Project	IEEE 802.16 Broadband Wireless Access Working Group < http://ieee802.org/16 >	
Title	Changes to chap. 15.2.1.1.2 in the Working Document	
Date Submitted	2006-07-10	
Source(s)	Mariana Goldhamer Alvarion 21, HaBarzel Street Tel Aviv, Israel	Voice: +972 544 22 55 48 Fax: +972 3 6456241 mailto: mariana.goldhamer@alvarion.com
Re:	IEEE 802.16h-06/015 – Working Group Review	
Abstract	Consolidation of the text and replacement of pictures	
Purpose		
Notice	This document has been prepared to assist IEEE 802.16. It is offered as a basis for discussion and is not binding on the contributing individual(s) or organization(s). The material in this document is subject to change in form and content after further study. The contributor(s) reserve(s) the right to add, amend or withdraw material contained herein.	
Release	The contributor grants a free, irrevocable license to the IEEE to incorporate material contained in this contribution, and any modifications thereof, in the creation of an IEEE Standards publication; to copyright in the IEEE's name any IEEE Standards publication even though it may include portions of this contribution; and at the IEEE's sole discretion to permit others to rep

Figure h13—Relation between Master sub-frame type 1 and the CXZ

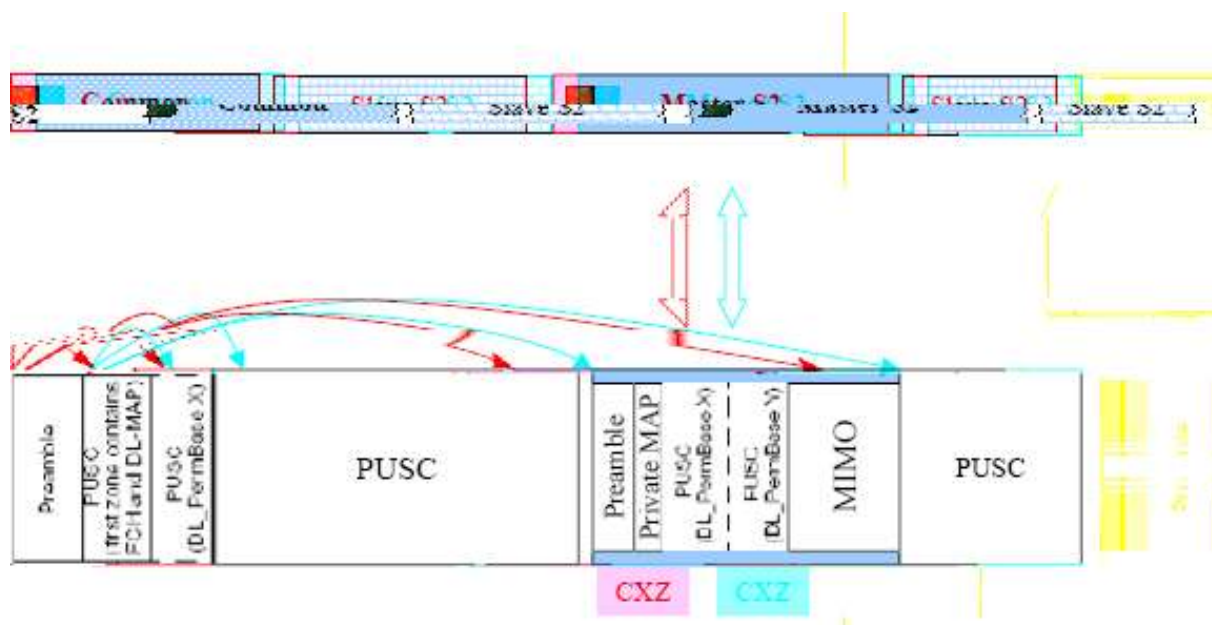
- Delete the text and fig. h10, related to sub-frame structure type 2, for the reason that it is not suitable for the 802.16 MAC frame structure, which always starts with a preamble, FCH and MAPs.
- Replace "type 3" with "type 2"
- Add text to explain the fig. h13 and h14, at line 52, page 36 and replace fig. h13 and h14:

The Coexistence Zone attributes will indicate to the SS the mode in which a CXZ is used. The CXZ scheduling as Master sub-frame gives an indication of limited interference during this time. An SS is allowed to use its maximum power during a CXZ.

The coexistence Zone may use a private MAP, due to the fact that users of the zone may not be able to decode the MAP at the beginning of the MAC Frame. The duration and scheduling of the CXZ are included in the CXZ IE (see 8.4.5.3.28 and 8.4.5.29).

Figure h9—Sub-frame structure type1

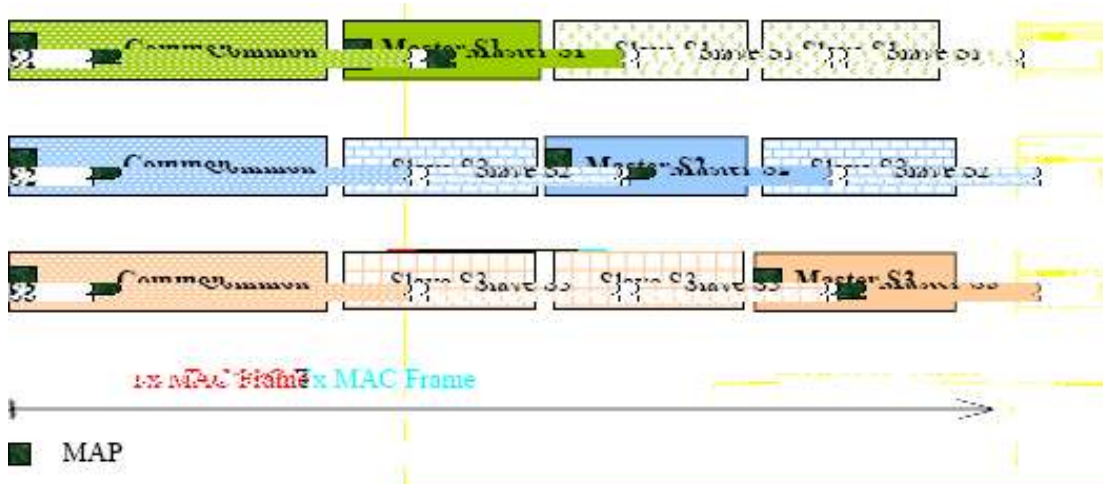
Replace the Fig. h9 and h11 with:
